Re: RM of Elton – Forrest Wastewater Treatment Lagoon Expansion – Licence #2560 R – Notice of Alteration

The RM of Elton is hereby requesting a Notice of Alteration for the Forrest Wastewater Treatment Lagoon Expansion – Licence #2560 R.

PROJECT: RM OF ELTON FORREST LAGOON EXPANSION - MWSB #1756
TITLE: PROPOSED LAGOON LAYOUT

SCALE: AS NOTED DATE: 22/12/21 PLAN: L2 SHEET: 03 of 06

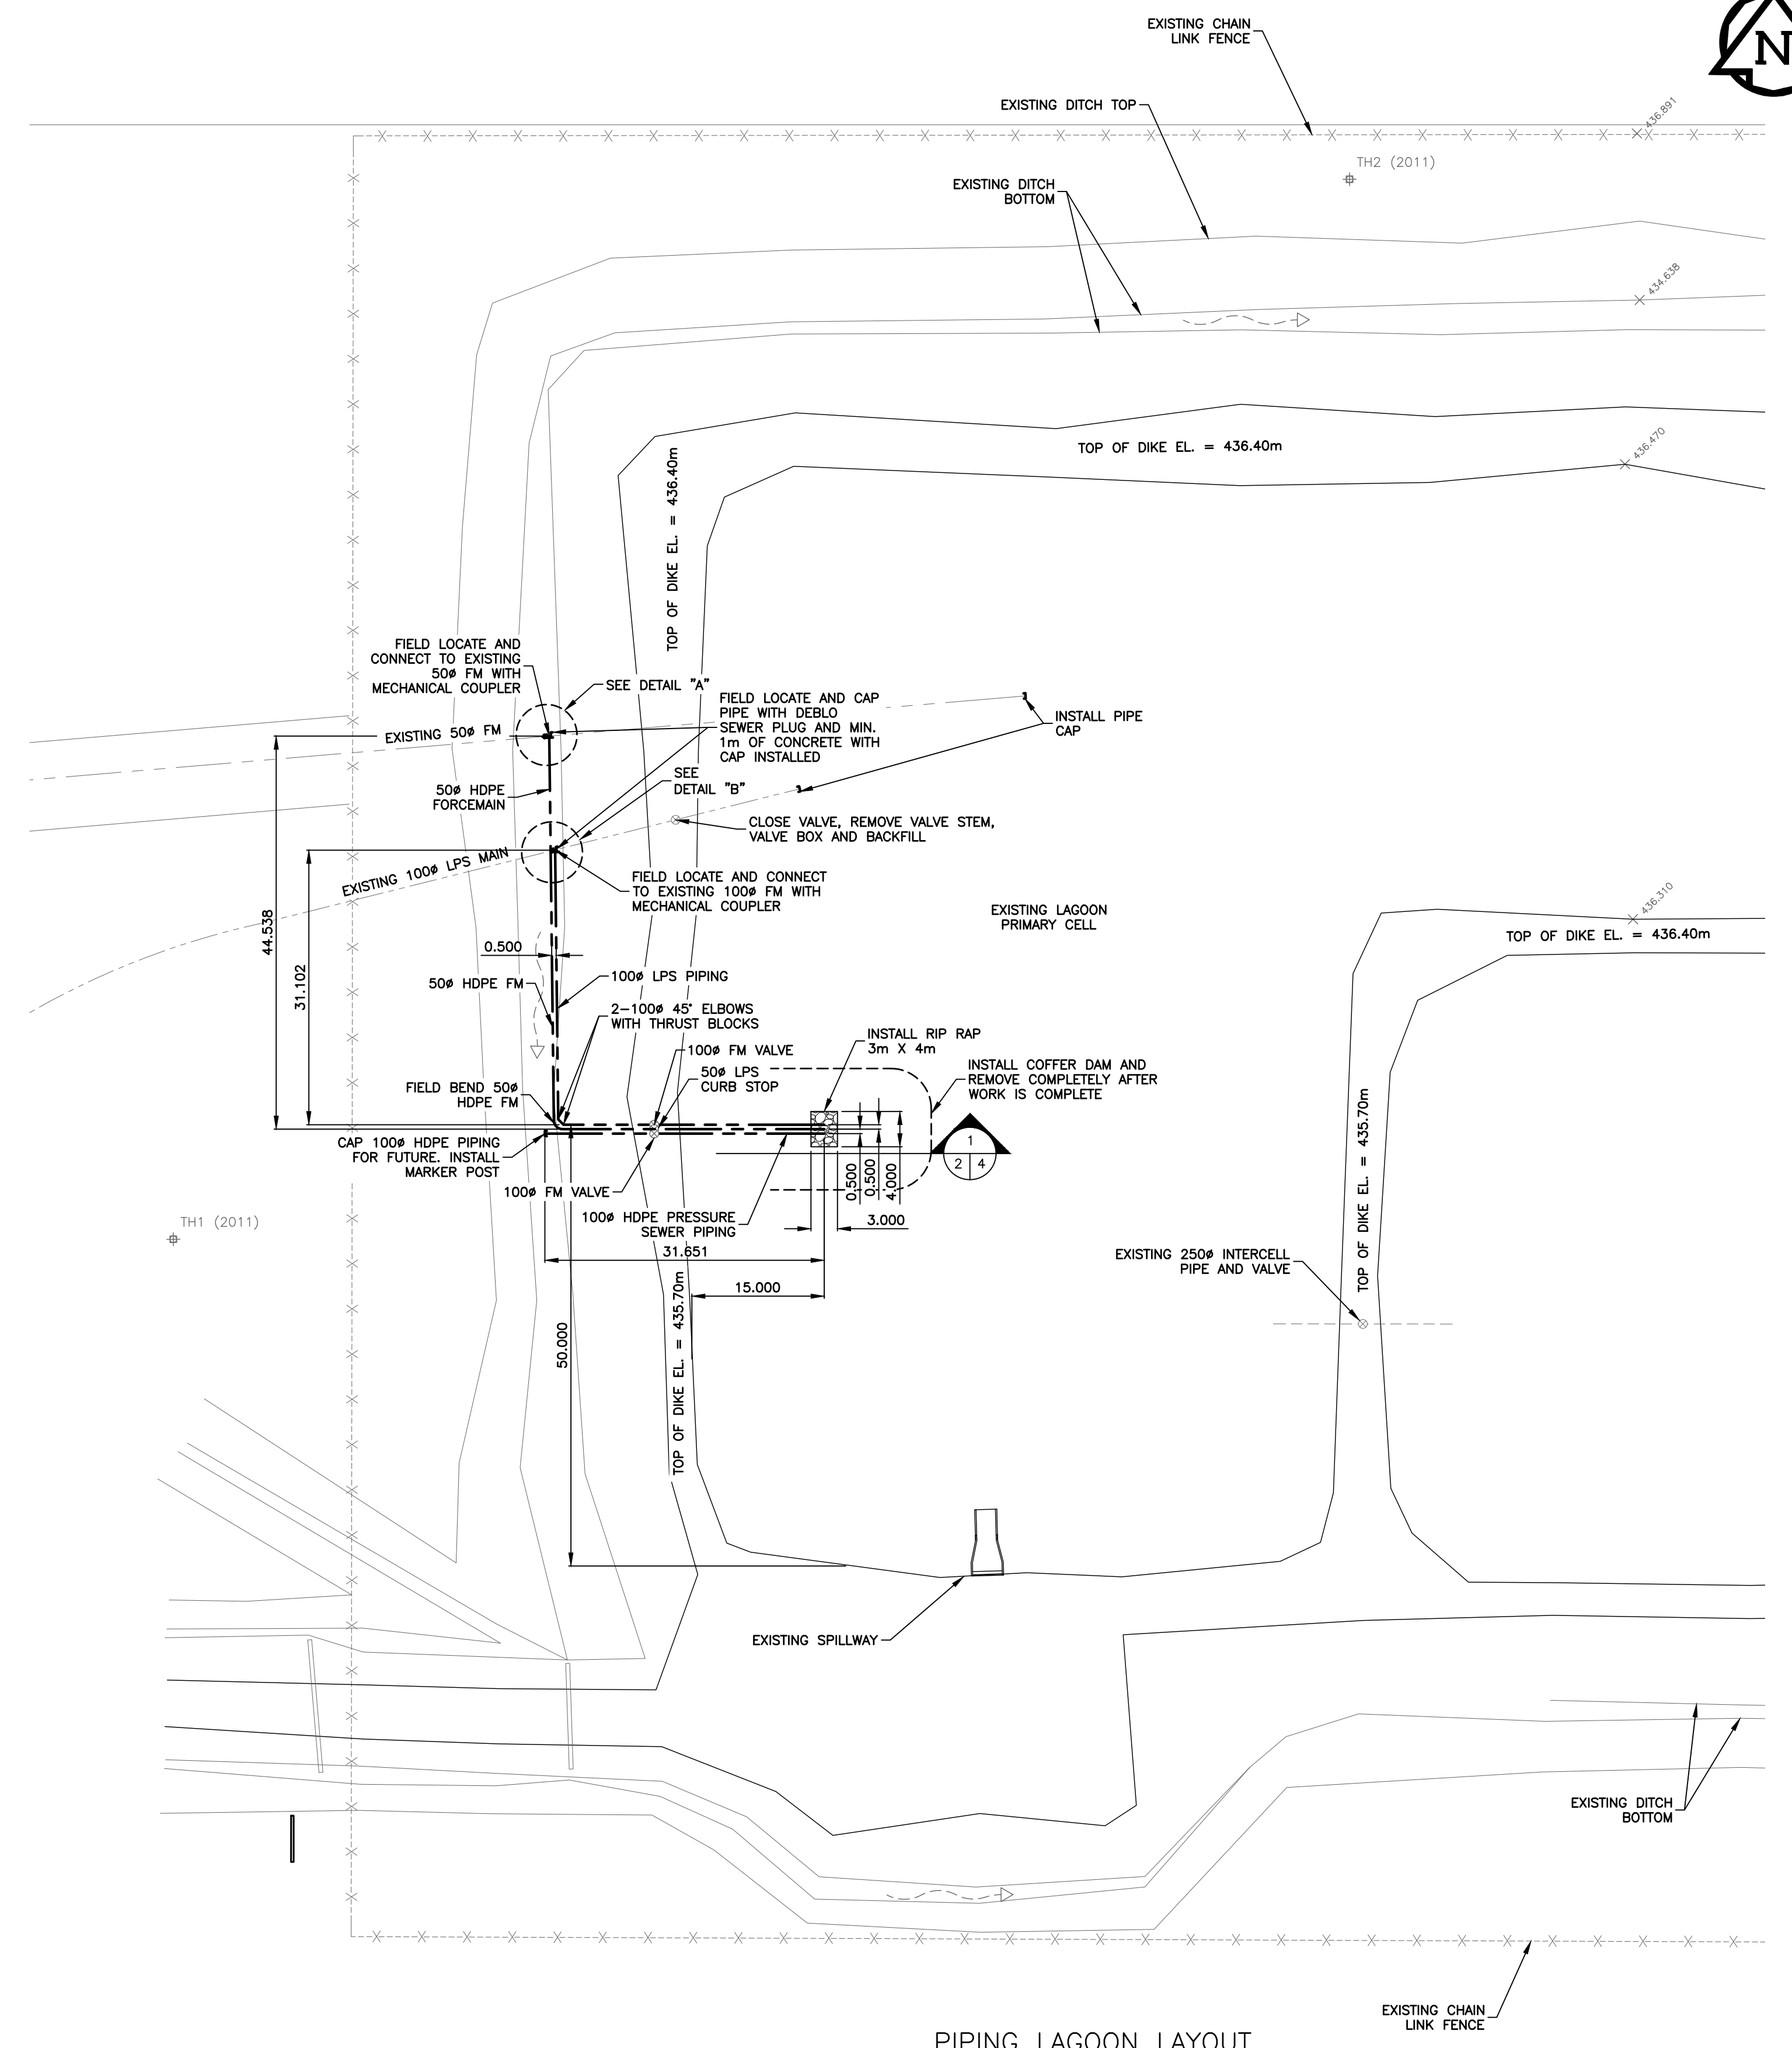
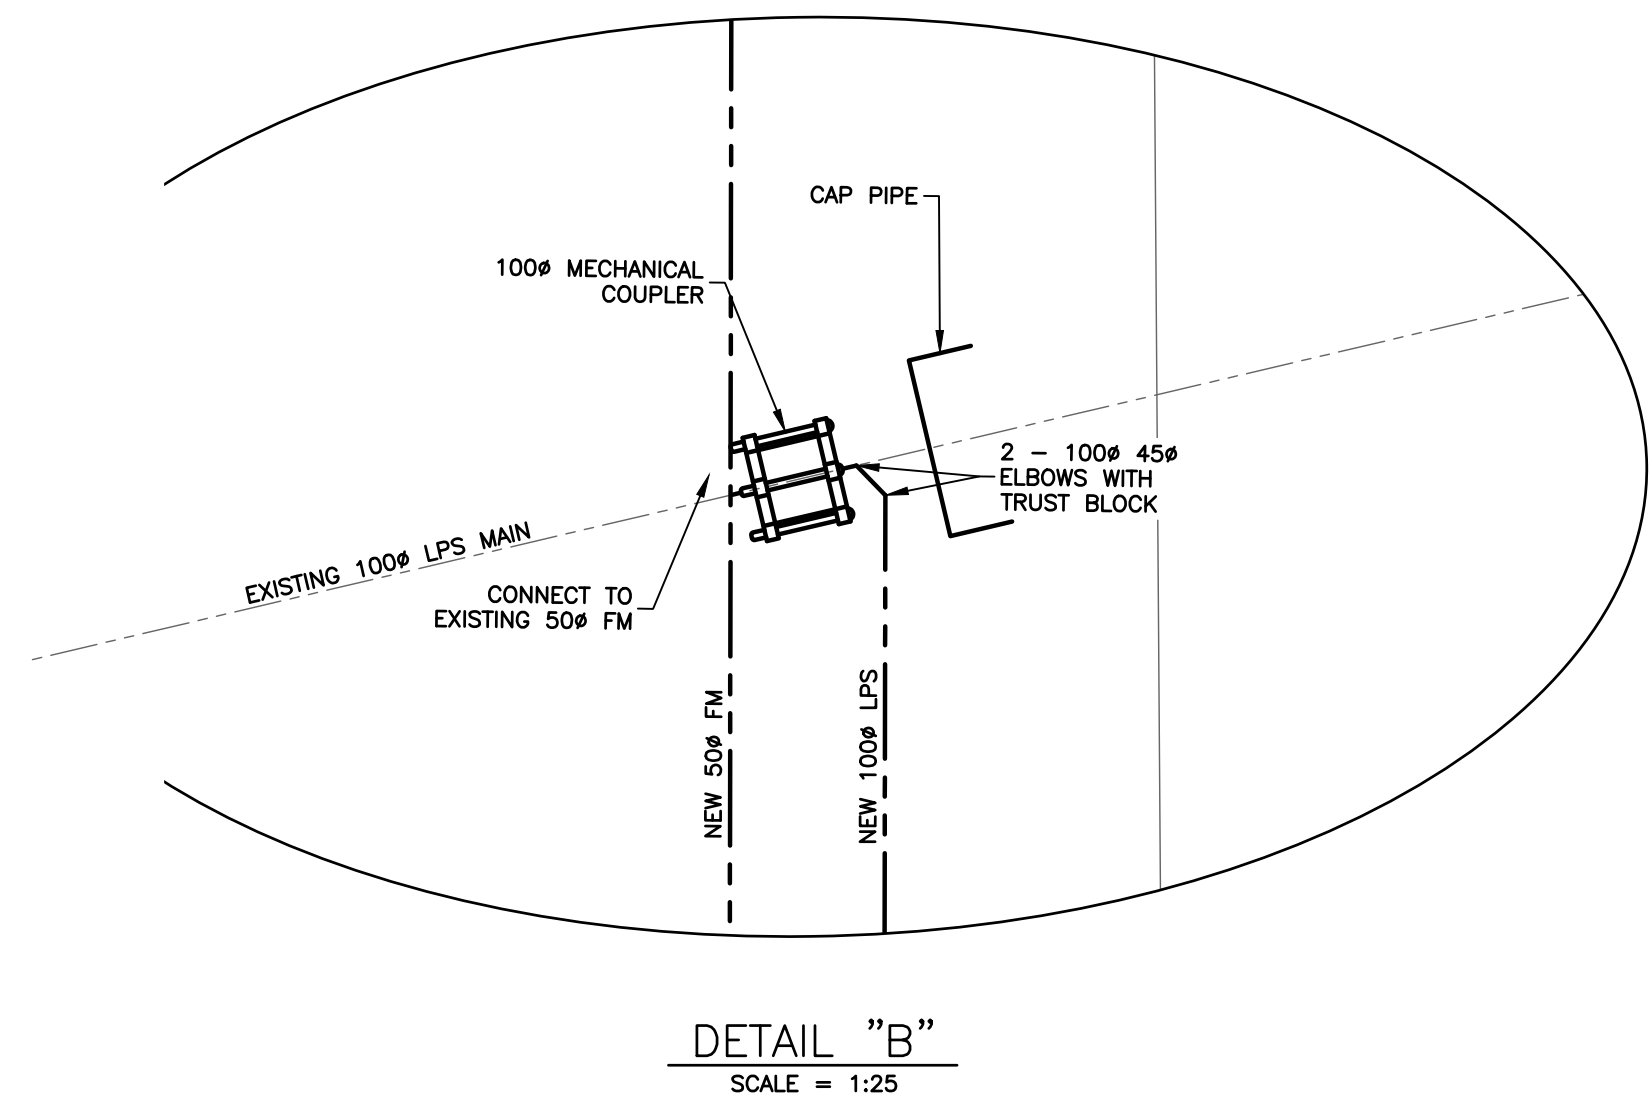
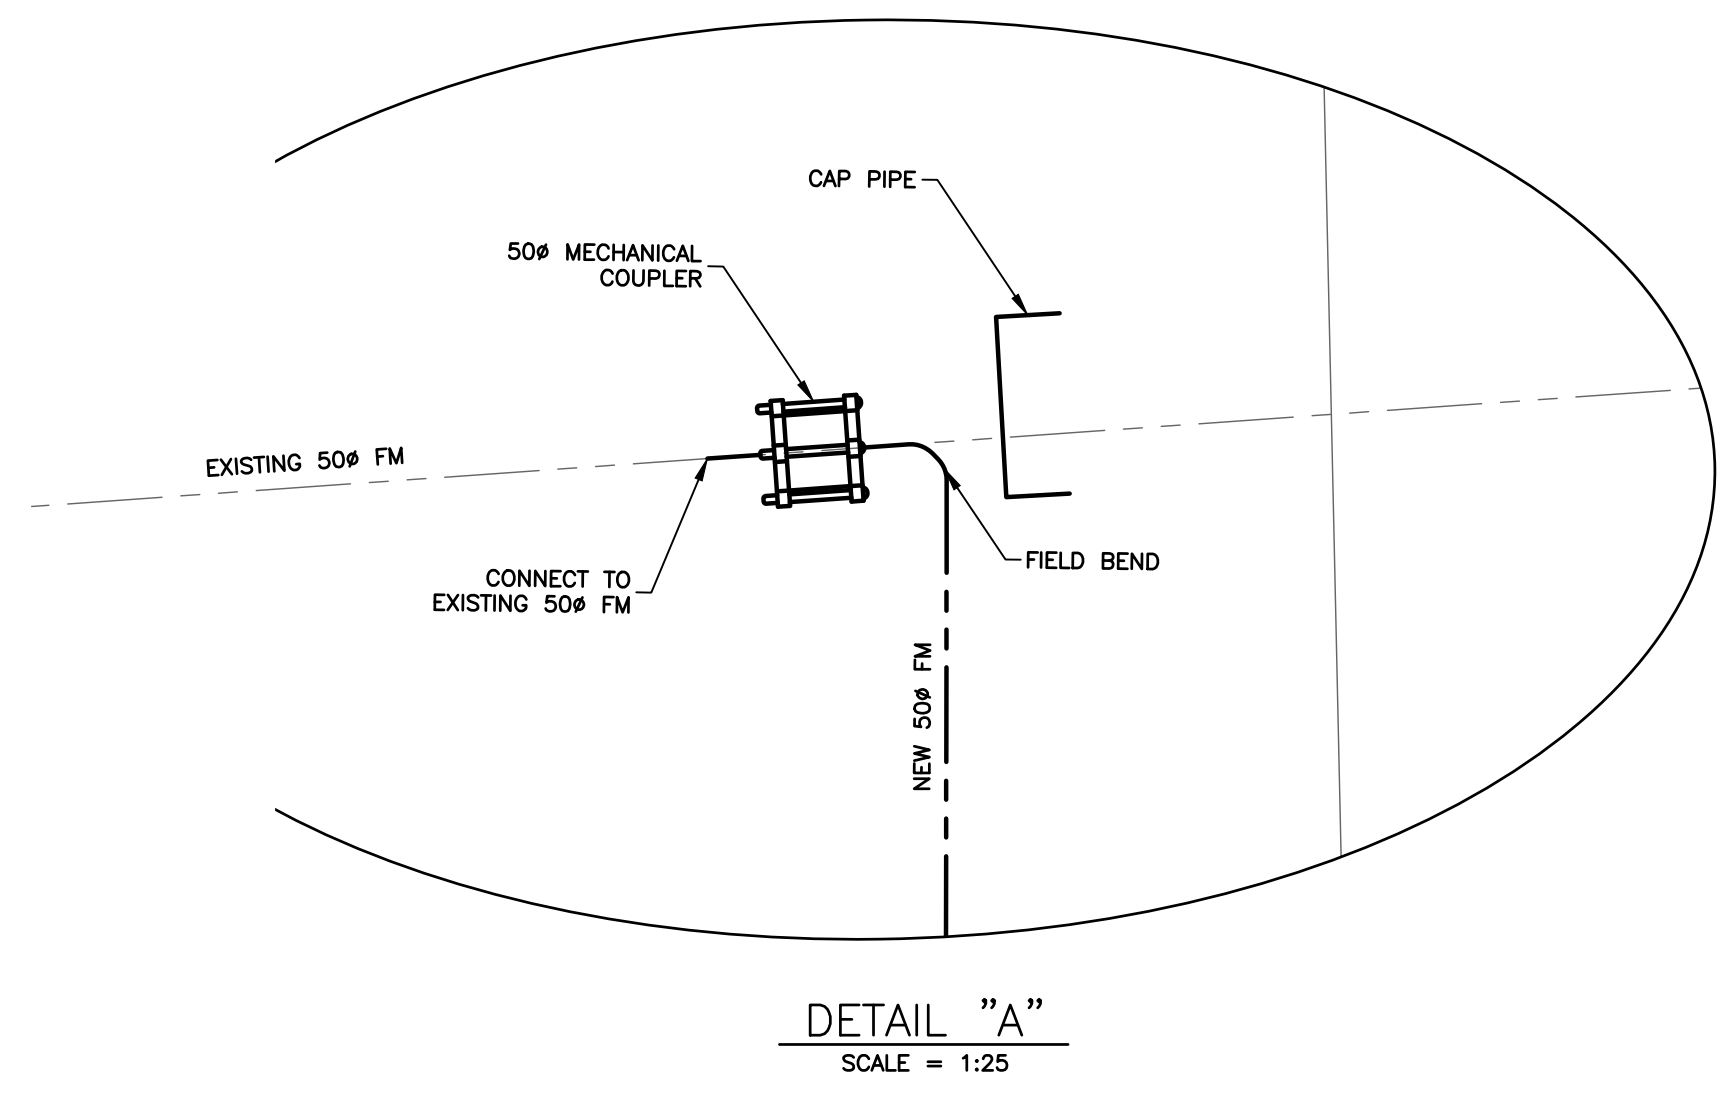
There are currently two existing forcemains to the lagoon. Both forcemains enter the lagoon in the north portion of the cell. The proposed work is to re-locate the forcemain inlets to the south, deeper portion of the cell. The change will assist the Operators to allow them to discharge the liquid in the top half of the primary cell in the fall without risk of the forcemain inlets freezing.

The RM of Elton also plan to install a third forcemain pipe stub for connection of a potential future low-pressure sewer forcemain.

See attached Plan L2 and Plan L4 for details of the proposed forcemain re-location work.

All trenching through the existing lagoon dike will be re-built using the insitu clay material re-compacted in lifts to 1 x 10⁻⁷ cm/s.

Title
**WASTEWATER LAGOON AND ROAD
 SITE PLAN**

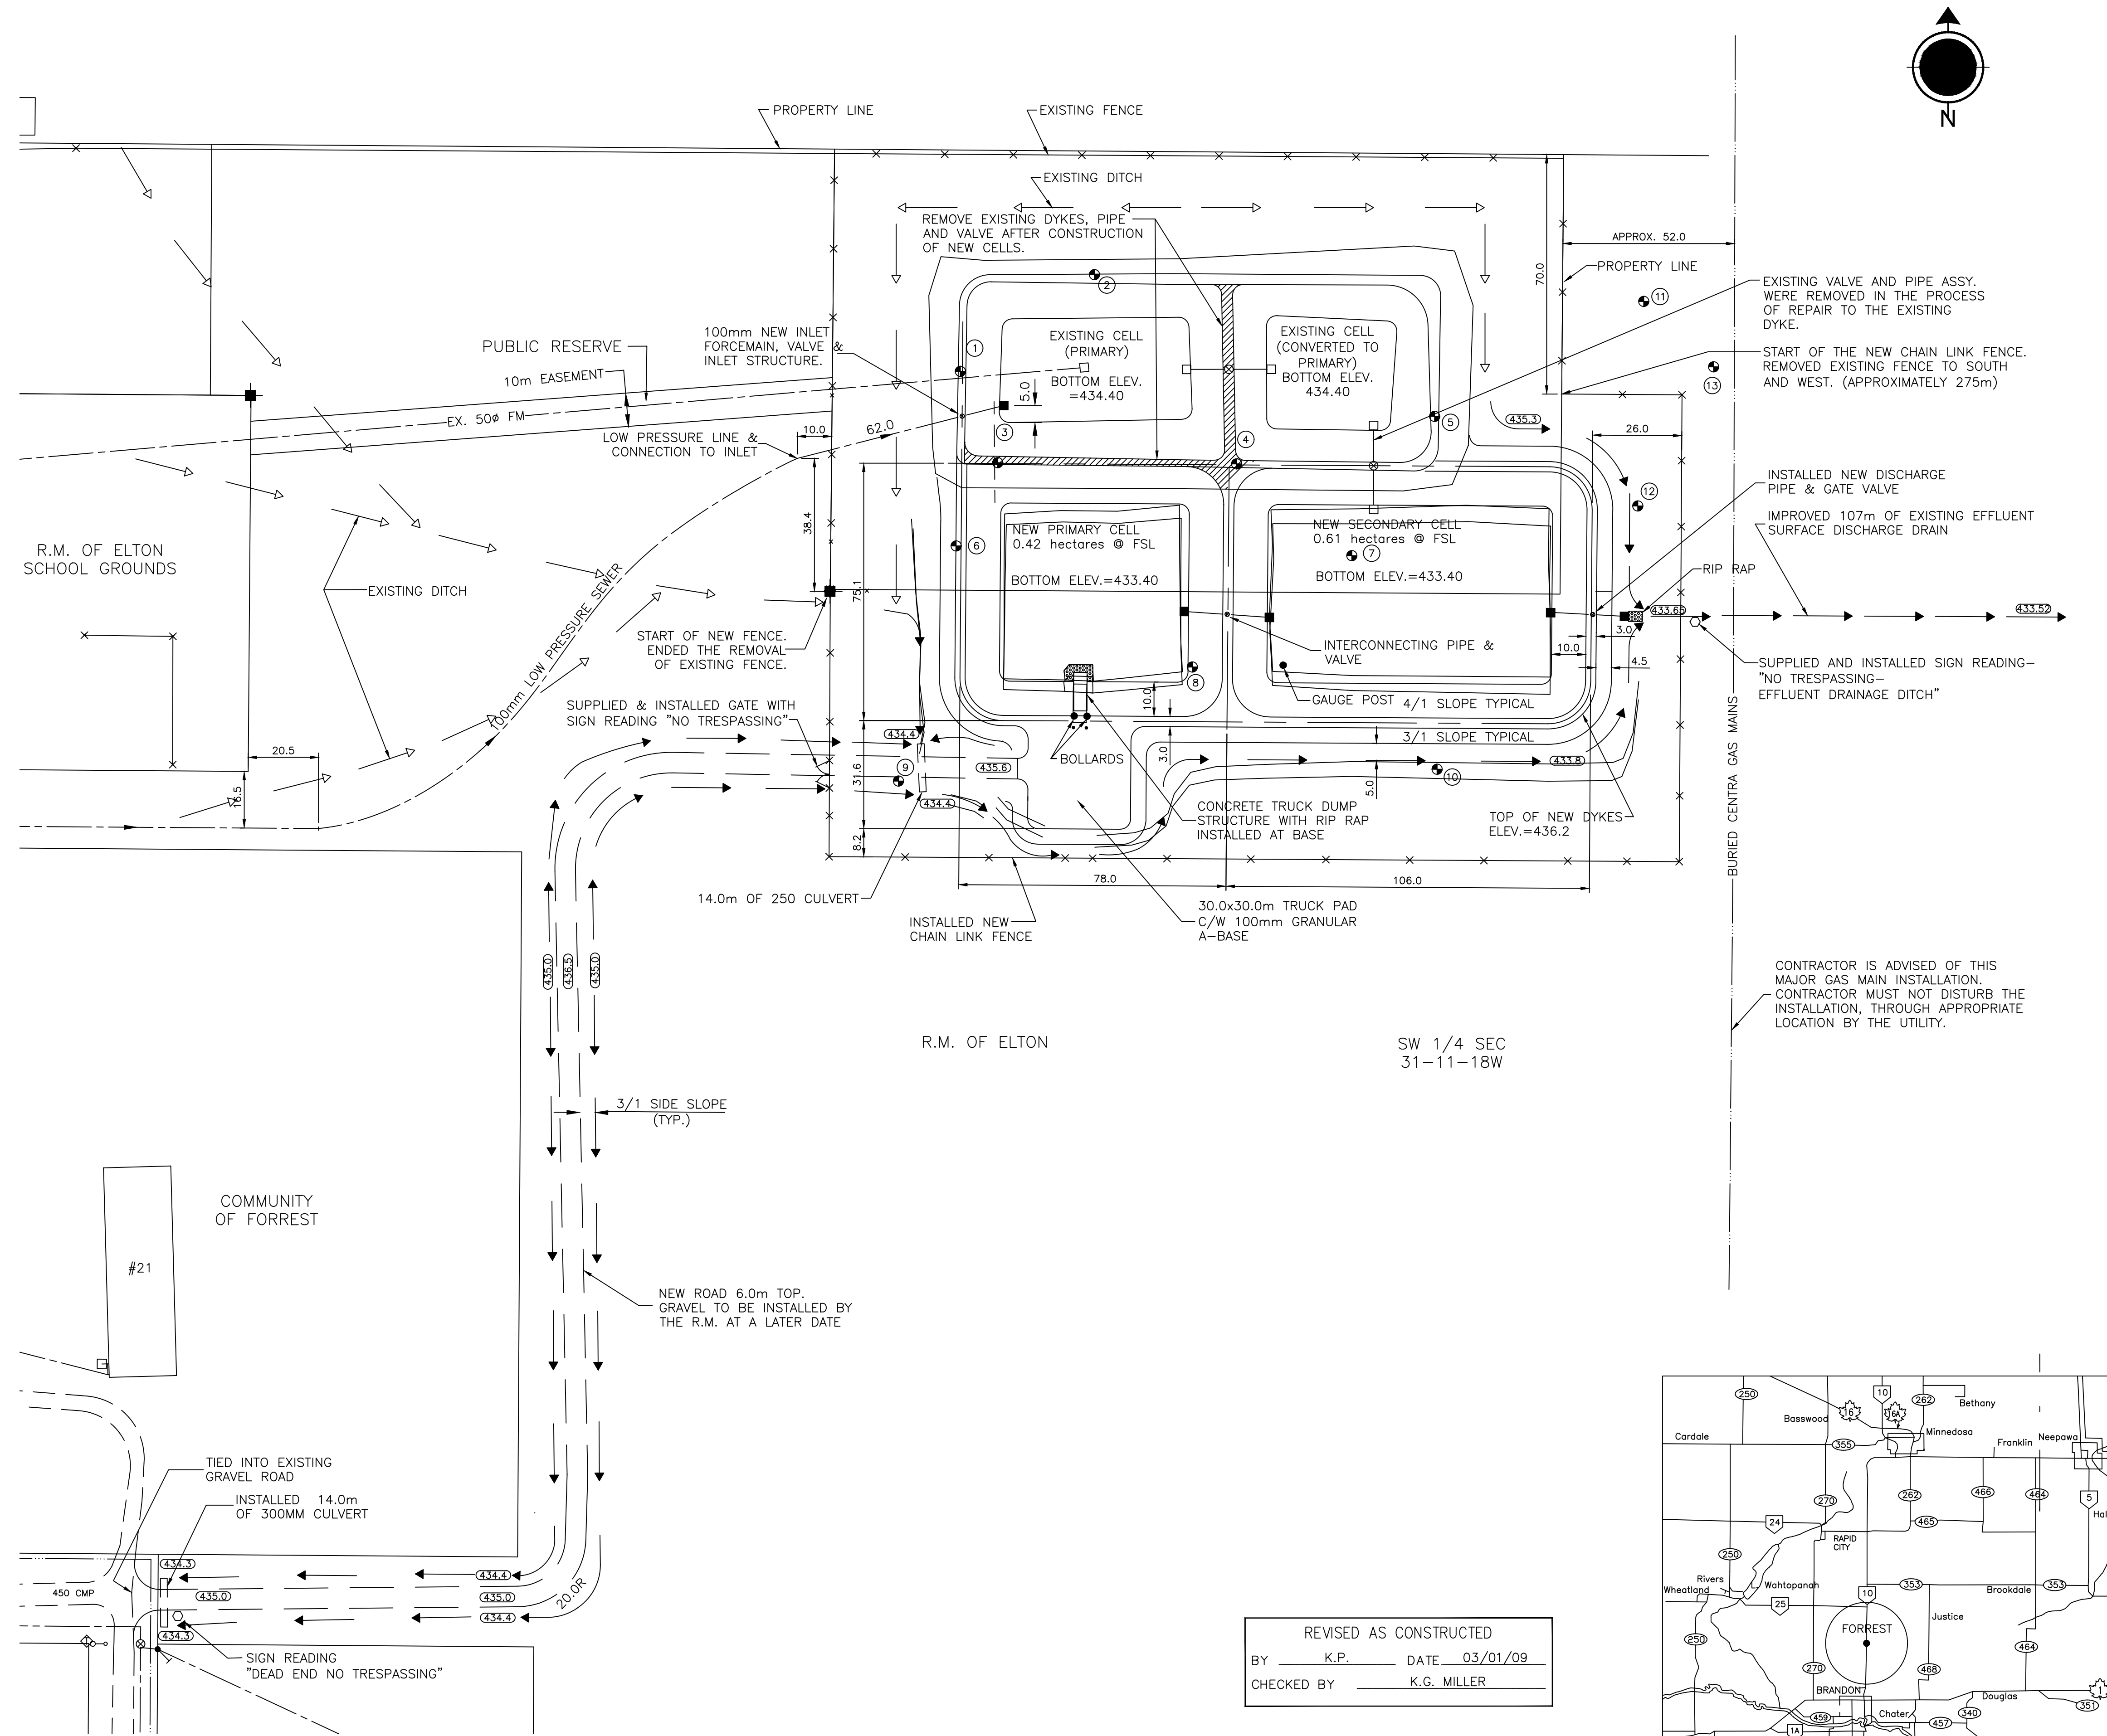
The proposed change is to re-locate the existing forcemain to the deeper portion of the existing primary cell. When the lagoon was expanded in 2003, the north portion of the primary cell was left at an elevation 1 m higher than the new south portion of the primary cell. See attached 2003 As-Built drawing by Stantec.
